REHABILITATION OF BRIDGE NO. 00255
I-395 OVER ROUTE 85

FEDERAL AID PROJECT NO. 0395(011)
STATE PROJECT NO. 152-158
TOWN OF WATERFORD

ADDENDUM NO. 2

FIGURE 1 - TRIAL PLACEMENT TEST SET-UP

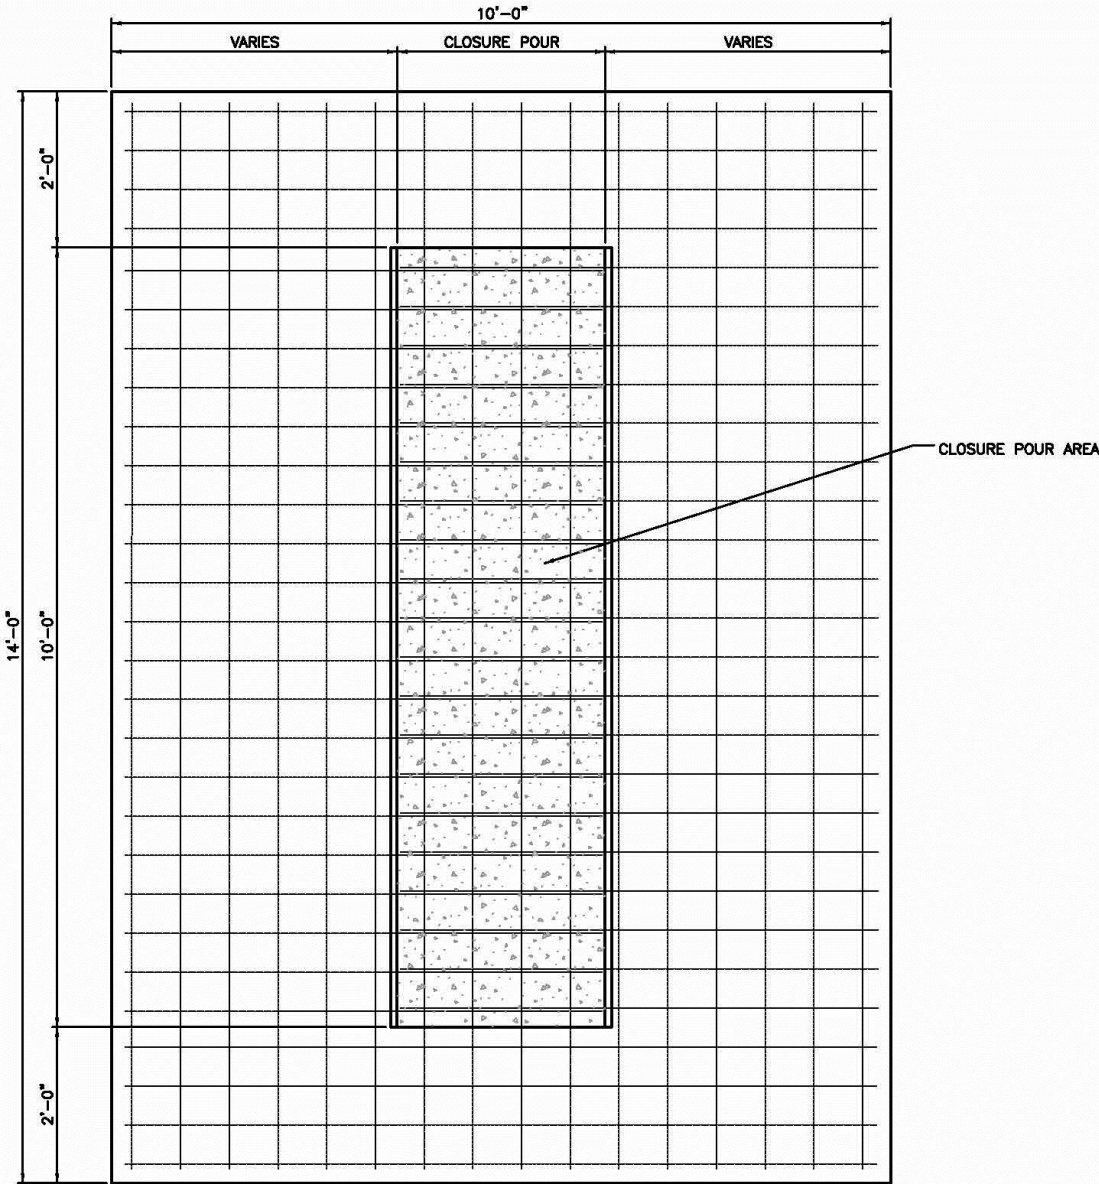
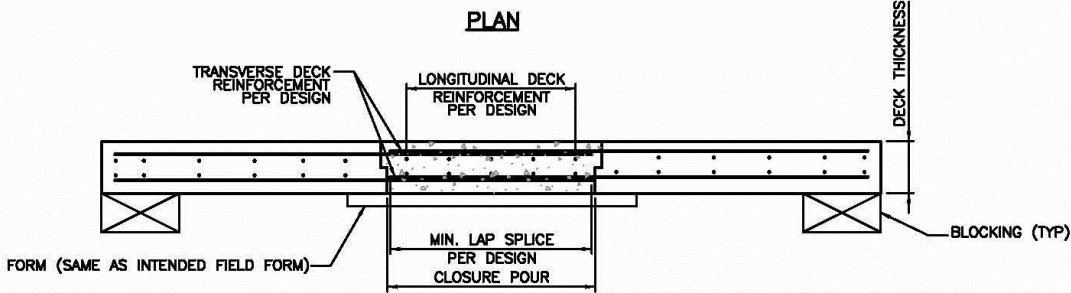
The details for the trial placement configuration are shown in Figure 1. Acceptance criteria for the trial placement shall be as follows:

- The trial placement concrete shall not exhibit cracking or separation from the test panel in excess of 0.016 inches wide
- There shall be no more than one transverse crack in excess of 0.010 inches wide in the 10 foot long pour.
- The evaluation of the trial placement shall take place 14 days after placement.

If the trial placement fails these criteria, the Contractor will be required to submit a corrective action plan on how repairs of these crack sizes will be performed. The Department may require the Contractor to conduct more trial batches and trial placements. The costs of trial batches, trial placements and the removal of trial placement concrete from the job site is incidental to the work and will not be measured for payment. The requirement for multiple test placements shall not be cause for a time extension.
